**Town of Kittery
 Planning Board Meeting
 August 24th, 2023**

ITEM 2 – 23 Bond Road– Shoreland Development Plan Review

**Kittery Planning Board
Findings of Fact
For 23 Bond Road
Shoreland Development Plan Review**

Re: Revision 2: Shoreland Development Plan Application
Applicant: Touchdown Capital, LLC, 23 Bond Road, Kittery, ME
Job No. 20-146

SUBSURFACE WASTEWATER DISPOSAL PLAN

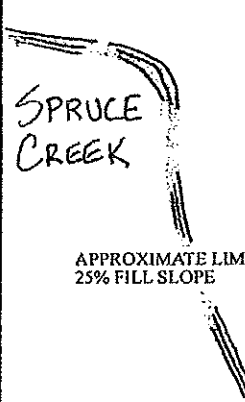
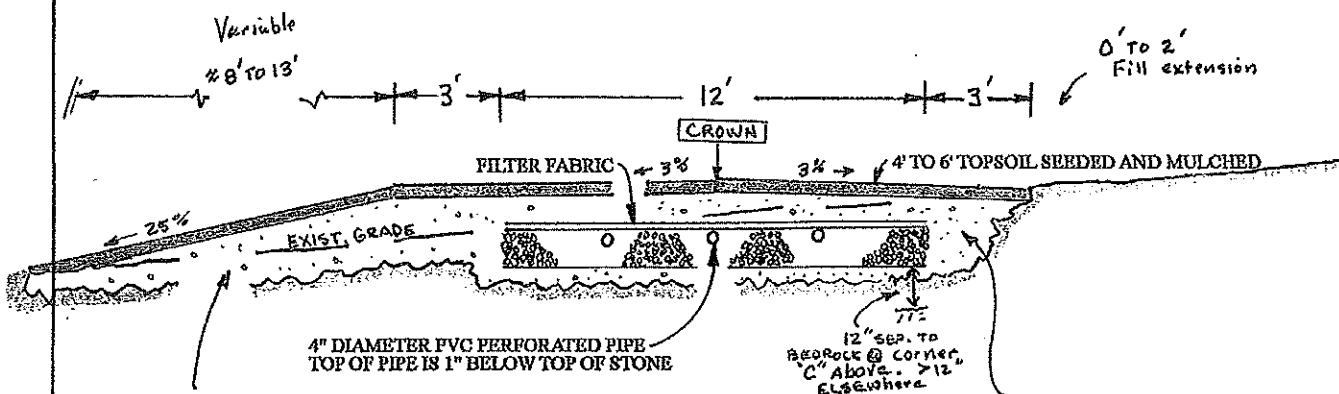
- 68 3. Concerns were raised regarding the proposed subsurface wastewater system for the property. The
69 proposed wastewater system has been inspected and approved by Code Enforcement staff, who
70 confirm it meets both Town and State requirements.

I understand that the Planning Board has asked about the proposed subsurface wastewater system for the Property. On July 31, 2023, the Kittery Licensed Plumbing Inspector (LPI) issued an HHE-200 permit for the proposed septic system. The new system will replace the existing overboard discharge system that drains into Spruce Creek. The new system will significantly improve effluent quality and volume because it will comply with current Maine Subsurface Wastewater Disposal Rules, 10-144 CMR 241.

In its review of projects subject to shoreland zoning, the Planning Board must find that the proposed development will “adequately provide for the disposal of all wastewater.” LUDC § 16.9.3(F)(2)(c). The Planning Board may find this standard has been met based on the Kittery LPI’s issuance of the HHE-200 permit pursuant to Maine wastewater rules.

SHORELAND DEVELOPMENT PLAN OF LAND LOCATED AT 23 BOND ROAD KITTEERY, YORK COUNTY, MAINE	
JOB #:	20-146
DATE:	MAY 18, 2023
SCALE:	1" = 20'
SHEET:	1 OF 1

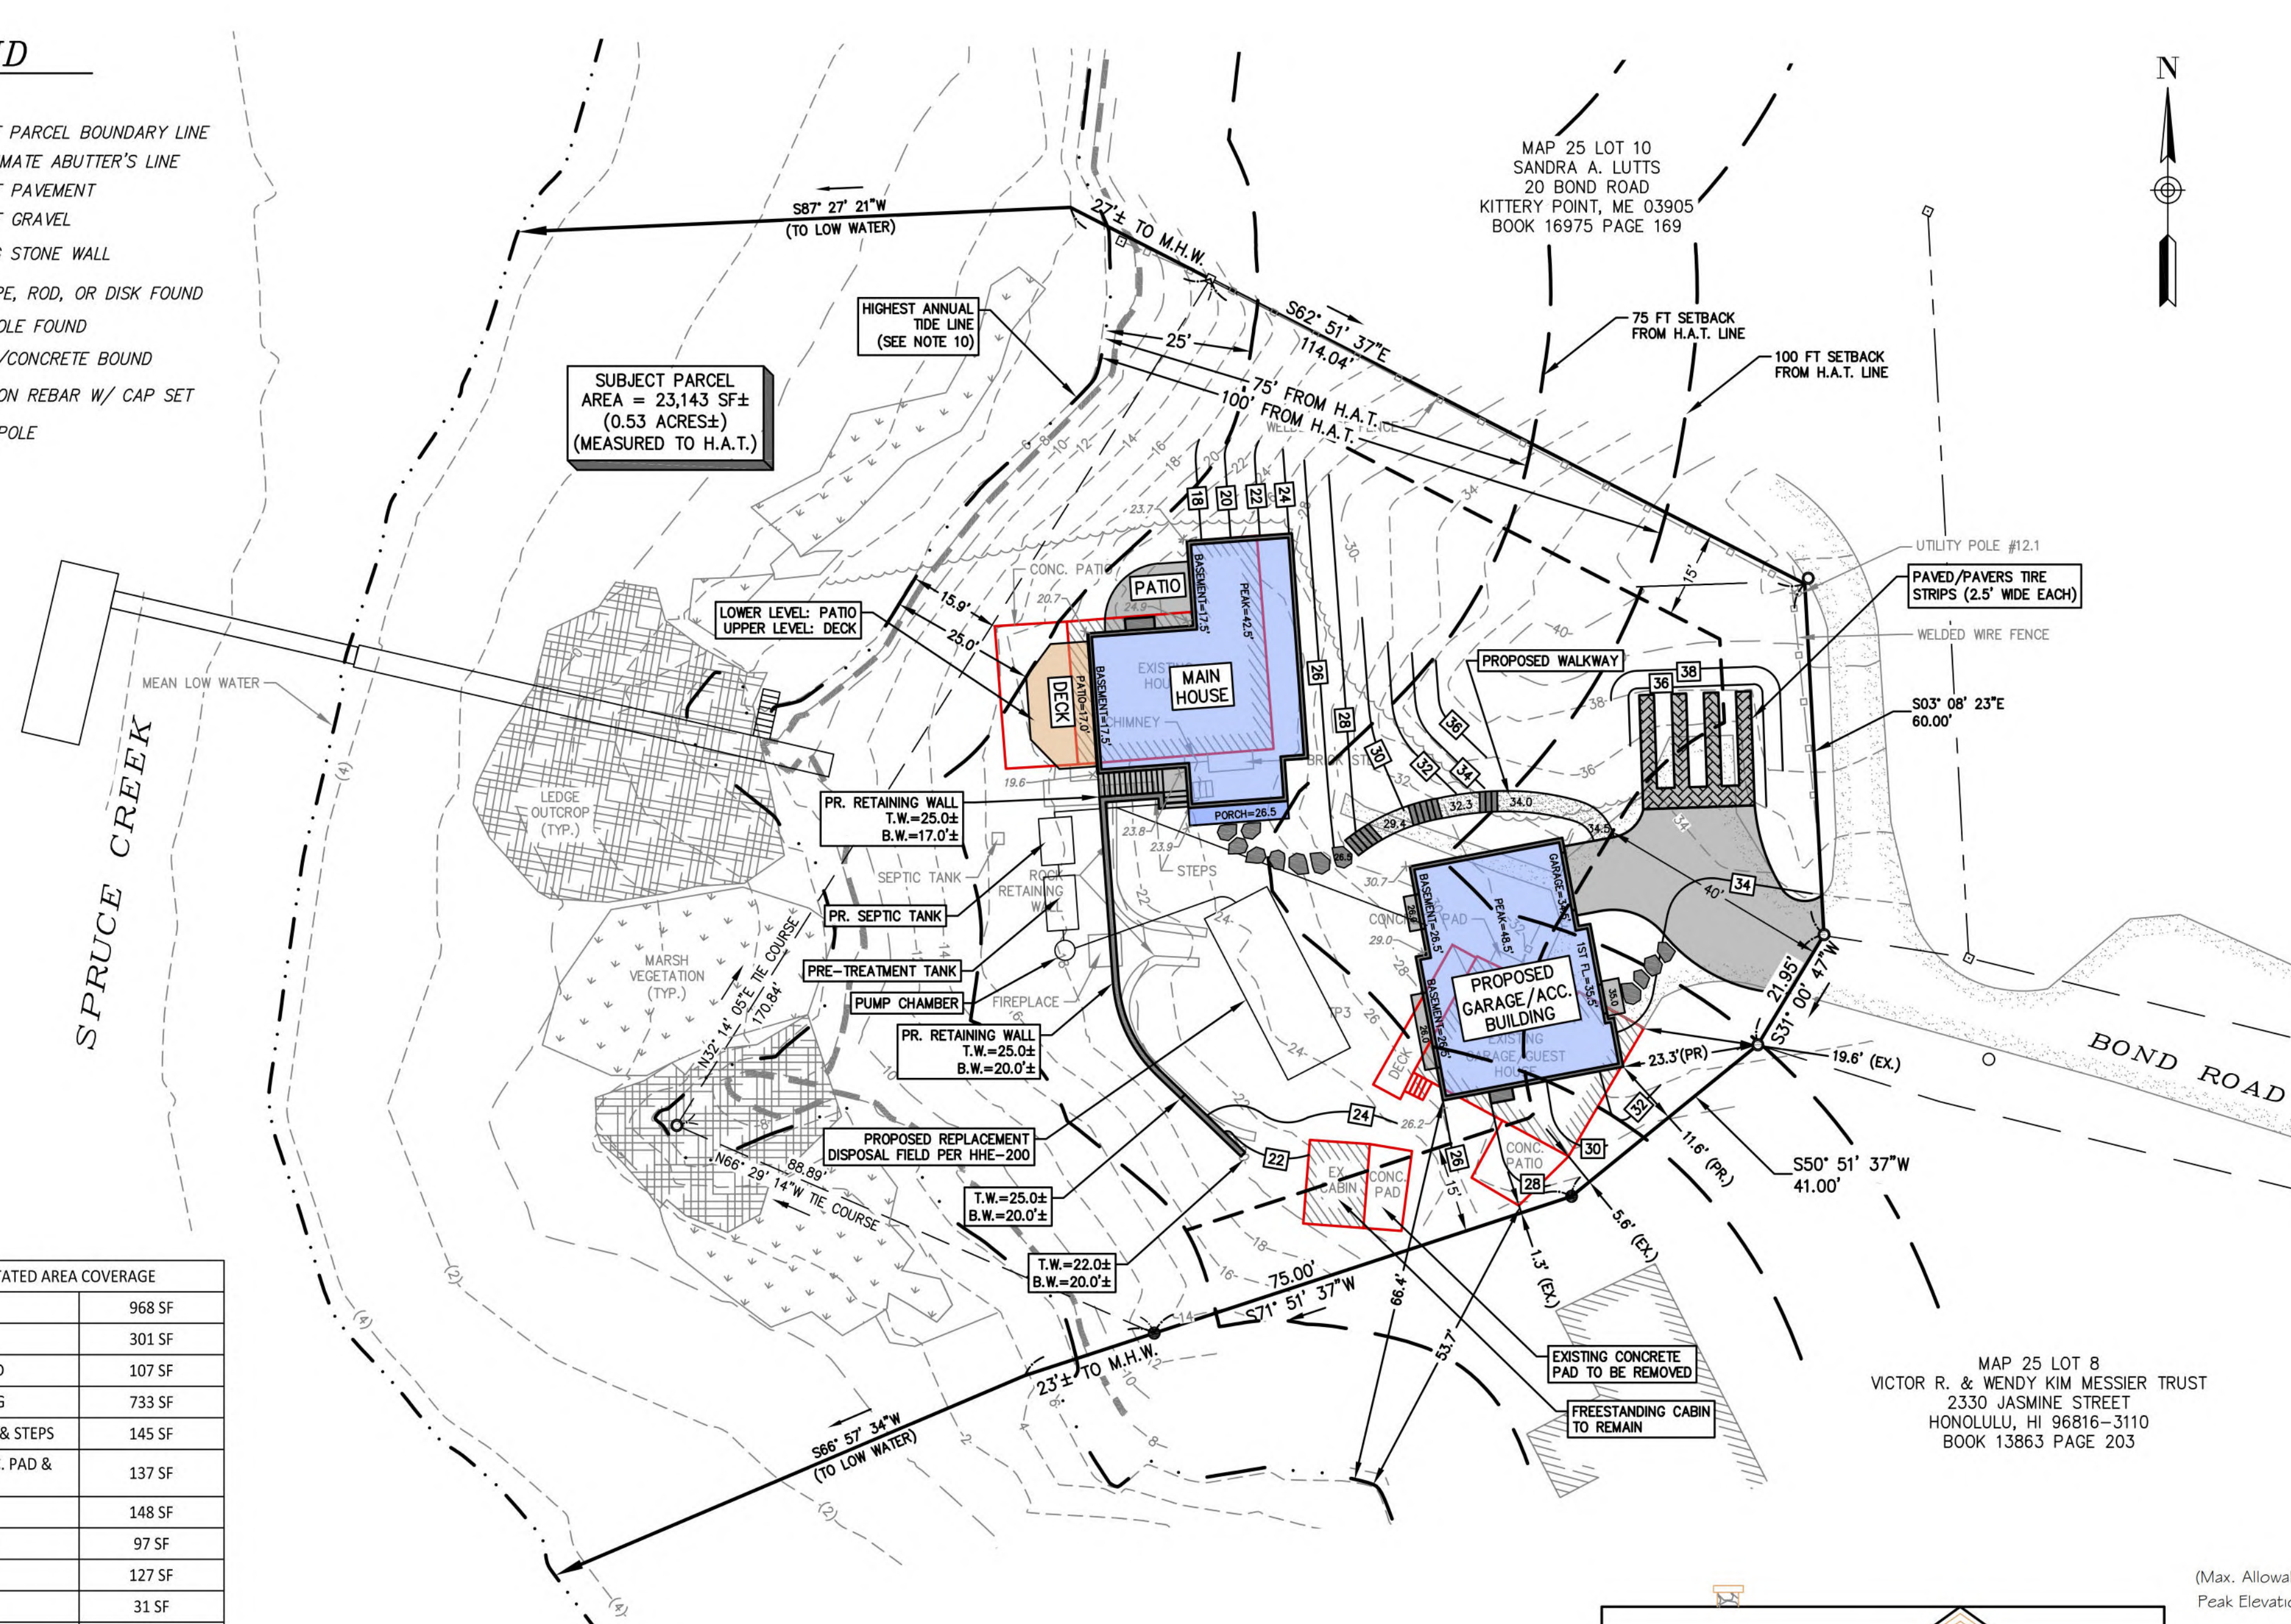
- 83 4. General provision §16.1.8.C.4.(b) requires expansion of structures within the base zone setback of
84 the HAT line not exceed 30% of the total footprint of structures existing within the property on
85 January 1, 1989. The existing footprint is 2,018 sq ft. The proposed plan would provide for an
86 expansion of 2,621 sq ft, or 30%, which is within the allowable limit.

- 87 5. The Shoreland Overlay Zone provision §16.4.28.E.3.(a) requires new principal and accessory
88 structures to be set back at least 100 feet, horizontal distance, from the normal HAT line of any
89 water bodies, tributary streams, the upland edge of a coastal wetland, or the upland edge of
90 freshwater wetlands. The application states the steep topography, steep ledge, existing mature
91 vegetation, and area of proposed new septic system prevent the house from being moved further
92 from the water line. Shifting the garage/guest house further from the water than proposed would
93 increase non-conformity with respect to the front yard setback.

- 94 6. §16.4.28.E.2 allows 20% of total lot area in the shoreland zoning overlay to be comprised of non-
95 vegetated surfaces or structures. With a lot size of 23,143 sq ft, current devegetation sits at 4,379
96 sq ft, or 18.9%. The plan proposes to increase coverage to 4,619 sq ft, which meets the maximum
97 20% allowable coverage of the lot.
98

1. Updated the non-conforming expansion calculations to conform to the types of structures identified by the Town staff in collaboration with the Maine DEP. This includes the buildings, porches, attached decks, and attached steps. Patios, retaining walls, walkways and paved surfaces were excluded as directed.

2. Reduced the size of the garage/accessory building from 1247 sf to 1181 sf which further improved the setbacks from Spruce Creek, the side lot line, and the front lot line.

3. Removed the northerly small deck on the main house and identified the patio on the walk-out level below.
4. Minor grading adjustments to accommodate the above changes.

5. Updated the devegetated area coverage calculations and the building coverage calculations accordingly.
6. Updated architectural plans to reflect changes to building size and floor plans.
